## **Accessibility Management Plan Overview**

# **Perry's Victory and International Peace Memorial**

Commonwealth Heritage Group, Inc., and  
National Center on Accessibility

**AUGUST 2018**

Figure 2-1. Visitor center area site plan, also showing the administration building, superintendent's house (men's dormitory), and the ranger operations center (ROC). Commonwealth.

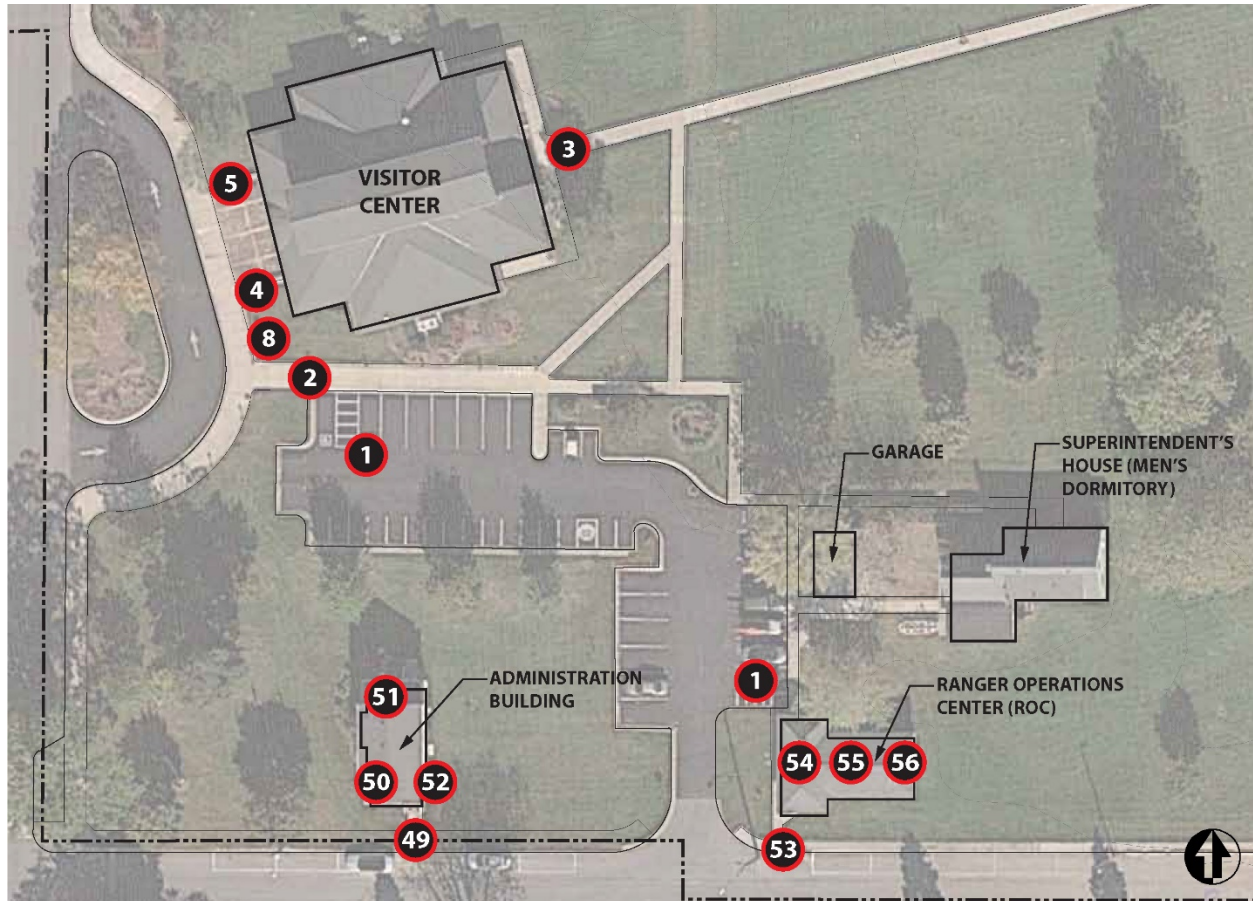
- 1) Accessible Parking: There are 22 car parking spaces, including three accessible spaces adjacent to the visitor center, in a lot that provides parking for both the visitor center and the ROC (see Figure 2-1). The minimum number of accessible spaces required for a total of 22 spaces is one (ABAAS F208.2, Minimum Number, and Table F208.2, Parking Spaces). At least one space for every 6, or fraction of 6, accessible spaces must be van accessible (ABAAS F208.2.4, Van Parking Spaces). Currently, the three accessible spaces provided in this lot are sized for cars; two are close to the visitor center and one is close to the ROC; none of these are van-accessible. In addition, none of these accessible spaces are signed as such (ABAAS F216.5, Parking). The following actions are required:

- 2) Accessible Route from Parking Lot to the Visitor Center: The sidewalk leading from the accessible space to the main (west) visitor center entrance slopes at 6.25%, exceeding the maximum of 5% for a ramp without handrails, and does not have the required edge protection (Figure 2-3). In addition, the landing at the bottom of the sidewalk exceeds the maximum of 2.08% slope allowed. The following actions are required:

- Re-stripe the parking lot to provide for at least one van-accessible space, which must be a minimum of 132" wide, with an access aisle at least 60" wide (ABAAS 502.2, Vehicle Spaces). Alternatively, the van-accessible space can be 96" wide if the access aisle is at least 96" wide (ABAAS 502.2, Vehicle Spaces, Exception). The van-accessible space should be one of the two closest to the visitor center. However, better access can be provided for staff requiring accommodations for a disability if the car-accessible space next to the ROC is also re-striped for van parking because, without it, the main door into the ROC would be over 200' from the one planned van space close to the visitor center, which would conflict with ABA standards (ABAAS F208.3, Location).

- Add an ABA-compliant handrail to each side of the ramp that extends west from the landing to the visitor center walkway (ABAAS 505, Handrails).

- Add 4" high edge protection on each edge of the ramp. This could be provided in the form of a low rail at 4" off the surface of the ramp that is part of the handrail structure, or by using other methods (ABAAS 405.9.1, Extended Floor or Ground Surface; or 405.9.2, Curb or Barrier).

Figure 2-15. Regional map showing military campaigns and battles during the War of 1812. National Center on Accessibility.

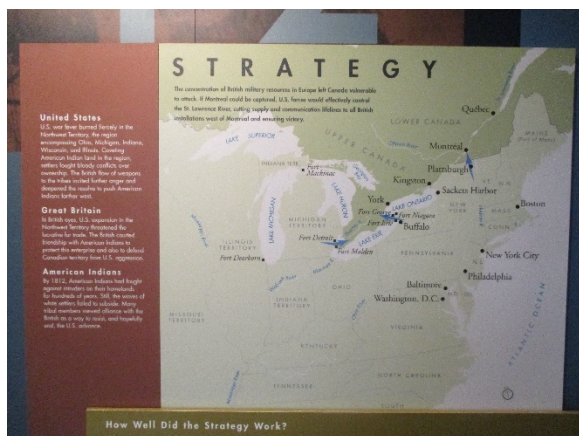
18) Maps: The visitor center exhibits contain several regional maps showing military campaigns and battles during the War of 1812 (Figure 2-15). These maps and the military strategy illustrated on them are not available to individuals who are blind or have low vision (Rehabilitation Act of 1973, as amended, Section 504; Programmatic Accessibility Guidelines for NPS Interpretive Media, 2017; Smithsonian Guidelines for Accessible Exhibition Design; NPS Director's Order #42).

Figure 2-16. Exhibit panels that present barriers for visitors with low vision due to limited color contrast between text and background and minimum font sizes. National Center on Accessibility.

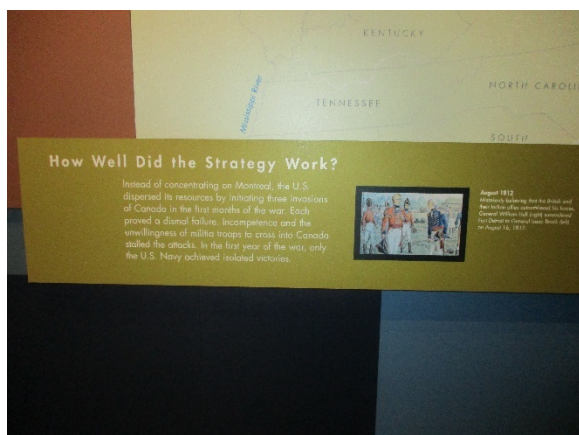
19) Low-Contrast Exhibit Text: A few of the interpretive exhibit panels in the visitor center present barriers for visitors with low vision due to limited color contrast between text and background (captions on *War of 1812, How Well Did the Strategy Work?*) and minimum font sizes (Figure 2-16). The minimum font size found on interpretive panels was 24 point; while this meets the minimum font size outlined in the *Programmatic Accessibility Guidelines for NPS Interpretive Media*, visitors with low vision would have to be very close to a 24 point exhibit label to read the information (Rehabilitation Act of 1973, as amended, Section 504; Programmatic Accessibility Guidelines for NPS Interpretive Media, 2017; Smithsonian Guidelines for Accessible Exhibition Design; NPS Director's Order #42).

- Work with an exhibit designer to create an exhibit design plan and replacement schedule for the panels and exhibits in the visitor center. As exhibits are replaced, ensure that the information is presented in a way that is accessible to the widest range of visitors. Things to consider in interpretive design include the use of sans serif or simple serif fonts (as opposed to serif fonts), minimal use of italics, the size of font in relation to reading distance (if space allows, a minimum 36 point font should be used, otherwise a minimum 24 point font can be used for nonessential text such as photo captions and labels, and a minimum 36 point font can be used for primary text), contrast between text and background of 70-95 percent, and the incorporation of audio and tactile elements (as discussed in separate work orders). Include the most pertinent information contained on the interpretive panels into the proposed audio described tour of the visitor center (contained in a separate work order). Consult the Programmatic Accessibility Guidelines for NPS Interpretive Media and the Smithsonian Guidelines for Accessible Exhibition Design for additional information on accessible exhibitions, including viewing heights, exhibit cases, labeling, and reach ranges for interactive components.

Figure 2-24. Memorial column floor plan, entry level.

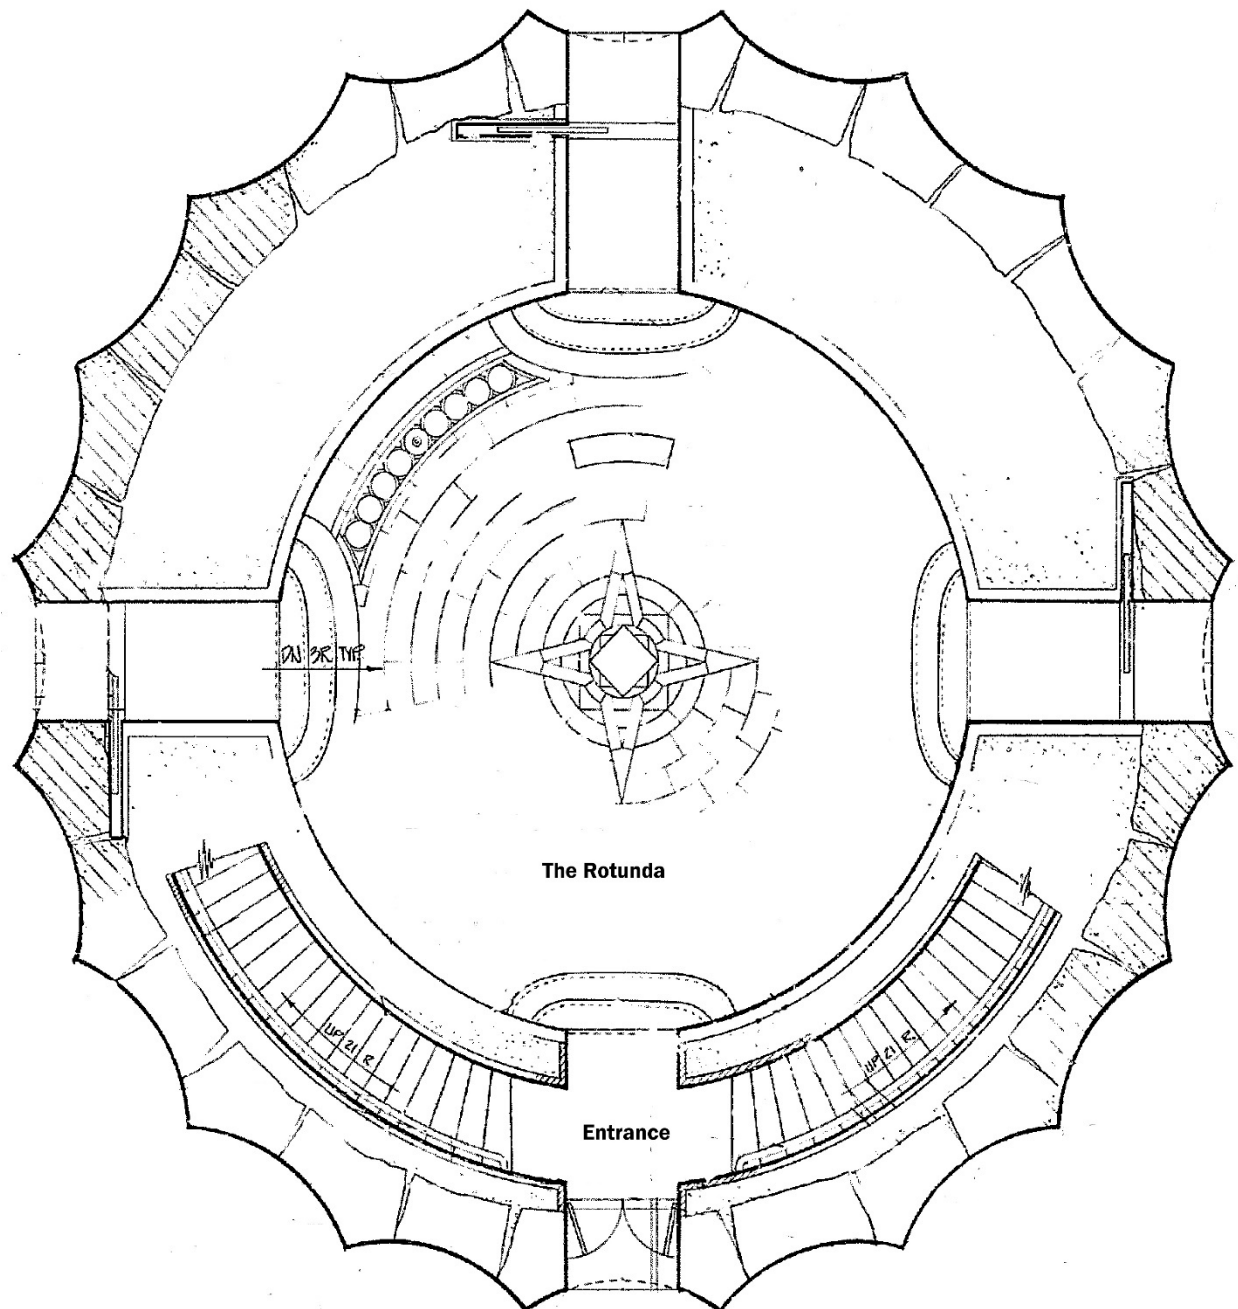
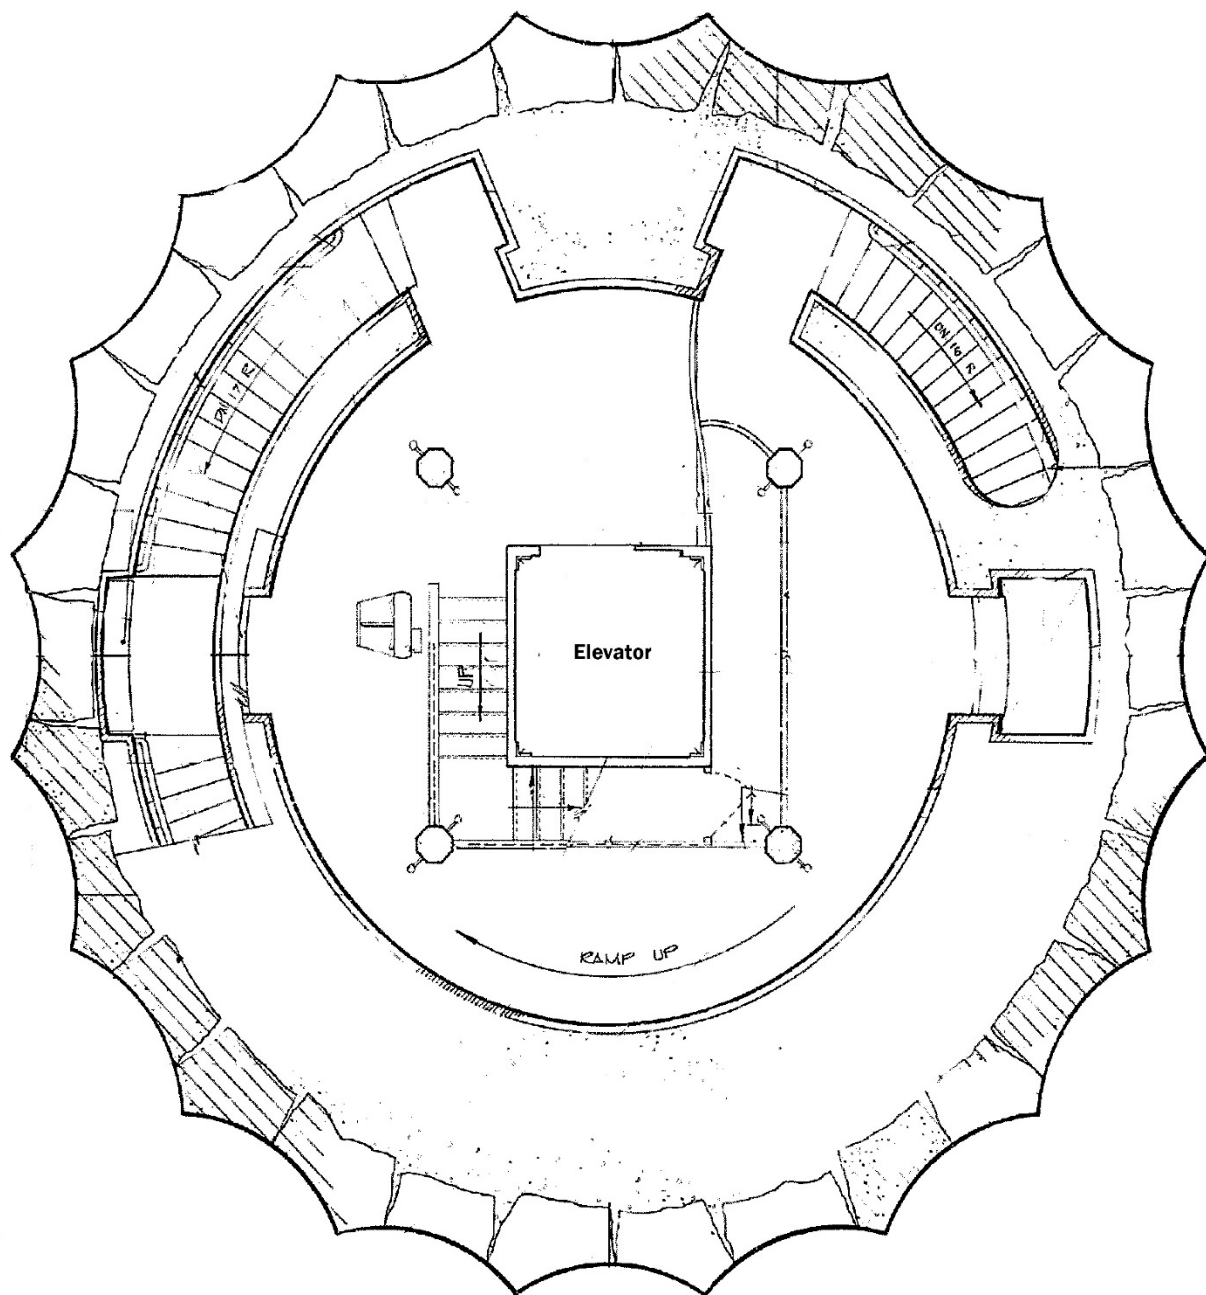
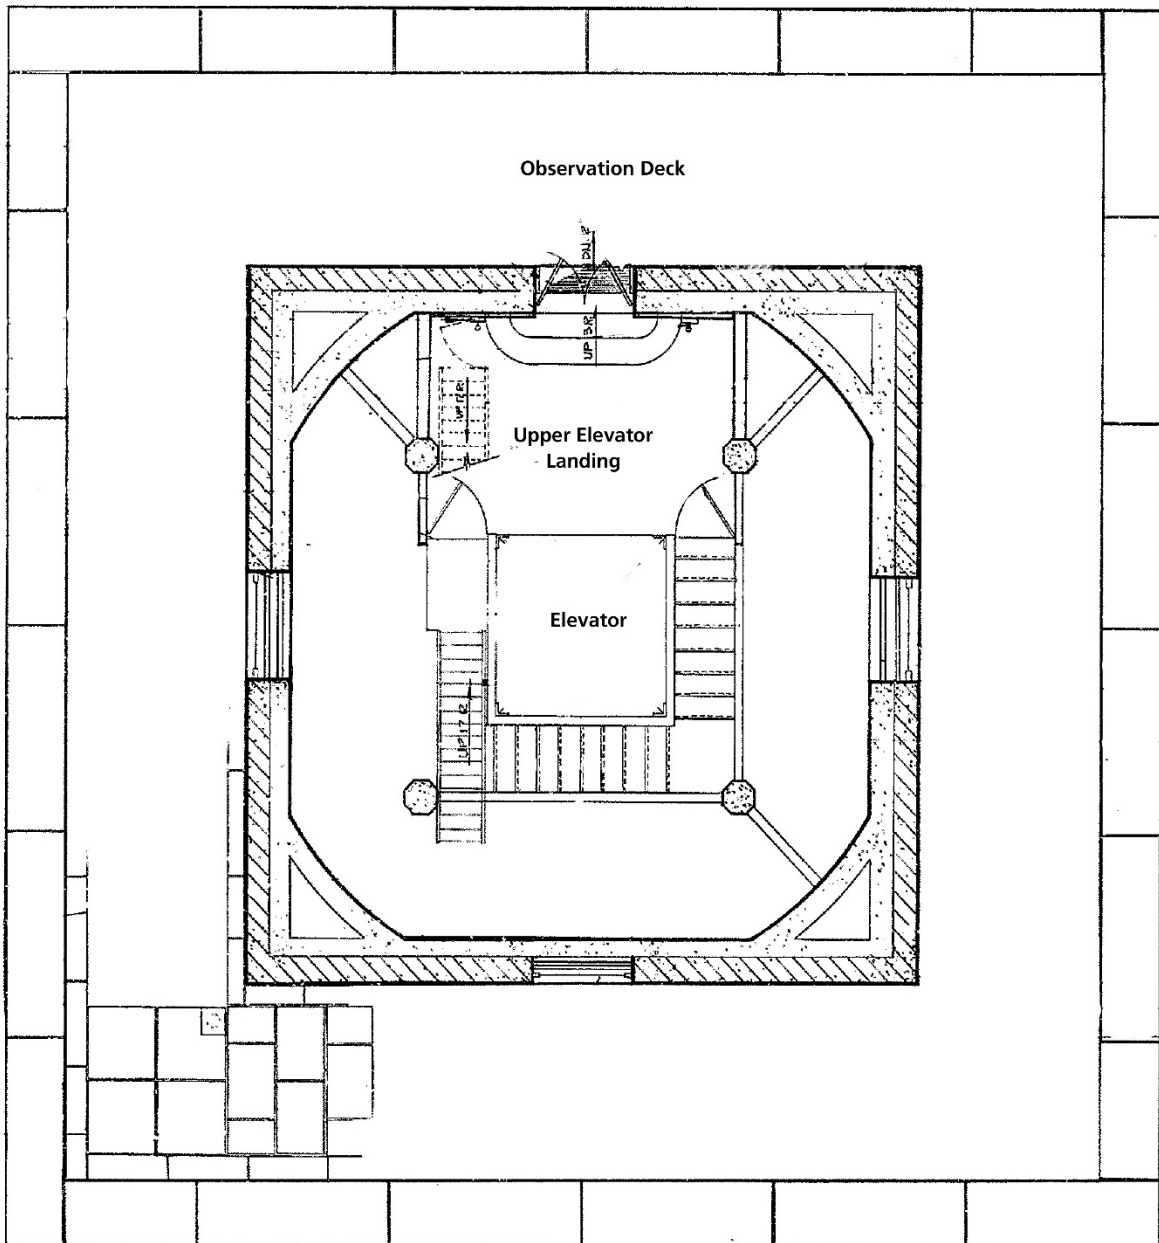
31) Accessible Route to Observation Deck (Figures 2-24 through 2-26): There is no accessible route to the observation deck of the memorial building, which prevents access to the 360-degree views of the battle site and other features. While there is an elevator to the observation deck, the elevator platform is at the top of a steep, narrow, 30-riser stairway. There are no plans underway to provide ABA-compliant access to the elevator and viewing platform for people who rely on wheelchairs or have other mobility challenges. The following actions can enhance access:

- Provide a way for visitors to participate in activities on the observation deck remotely through the use of a self-controlled camera or other visual or descriptive device.

Figure 2-27. Memorial building restrooms floor plan.

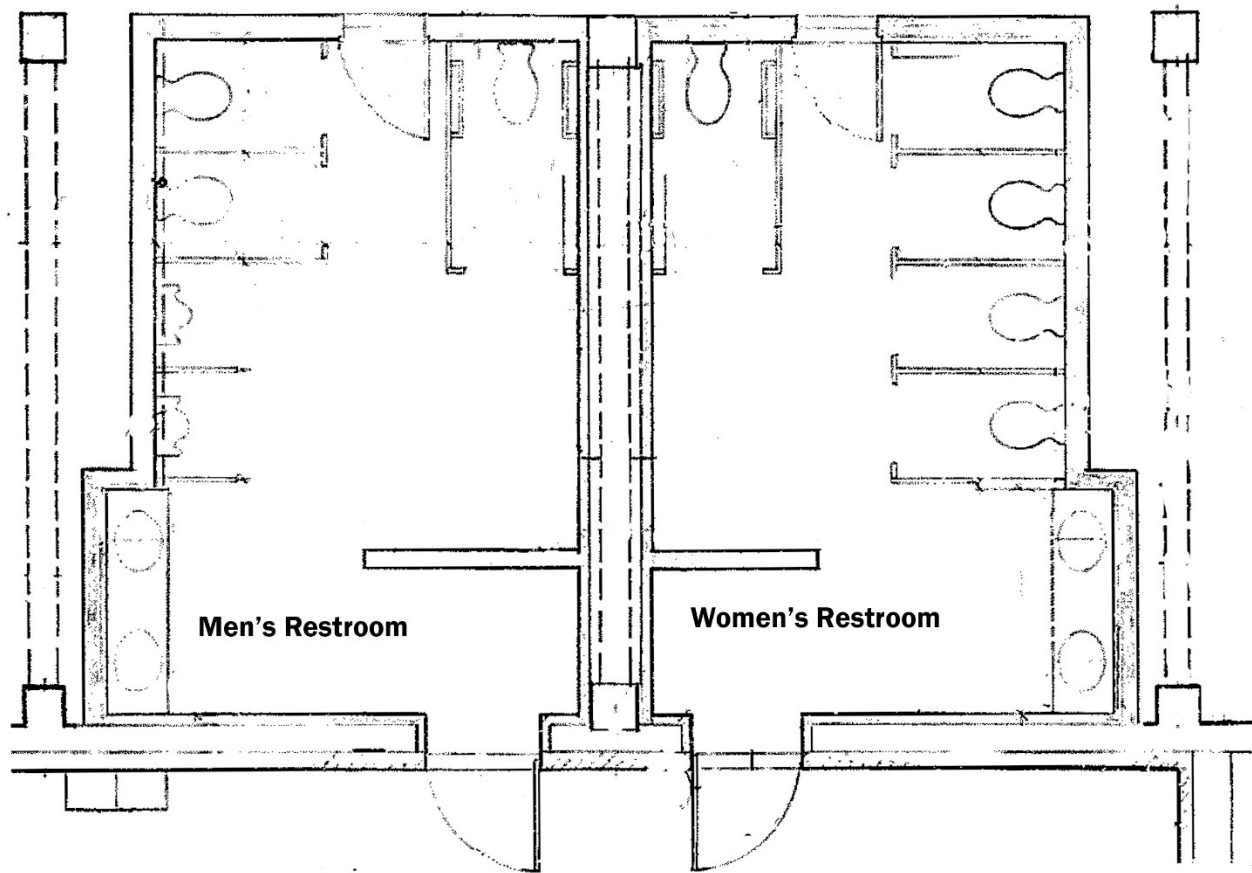
32) Restrooms (Figure 2-27): Restrooms for men and women are in the basement of the memorial building and are accessed from exterior doors; neither is accessible (ABAAS F213.2, Toilet Rooms and Bathing Rooms). Thresholds into both men's and women's restrooms are 1-1/2" high instead of the required 3/4" (ABAAS 402.2, Components) (Figure 2-28). There is no wheelchair-accessible stall in either restroom, which required clearance around a toilet of 60" minimum measured from the side wall, and 56" minimum measured from the rear wall (ABAAS 604.8.1, Wheelchair Accessible Compartments). Rim of sink in each restroom is 1" higher than the 34" maximum height for ABA compliance (ABAAS 606.3, Height) (Figure 2-29). Reflecting surface of mirrors is 41" instead of the maximum 40" above the floor surface (ABAAS F213.3.5 and 603.3, Mirrors). The sign on the outside of each restroom door is centered, which does not comply with ABA standards (ABAAS 703.4, Installation Height and Location) (Figure 2-30). The following actions are required:

- Add a threshold ramp at each door for maximum 3/4" high threshold. Block basement access door in each restroom to provide enough room for a wheelchair-accessible stall, which should be 60" wide, minimum, and 56" deep, minimum, for a wall-hung toilet. Ensure that the other features, such as grab bars and dispensers, and their locations comply with ABA standards (ABAAS 603, Toilet and Bathing Rooms, and 604, Water Closets and Toilet Compartments). Install under-mounted sinks so that rims are no more than 34" above the floor. Move the mirror above the sinks down 1" so that the bottom of the reflecting surface is 40" or less above the floor. Relocate restroom door signs so that they are on the latch side of the door.

- *Interim Solution:* Until the changes below can be made, provide an accessible portable toilet near the memorial building restrooms and provide signs directing people to the accessible restroom.
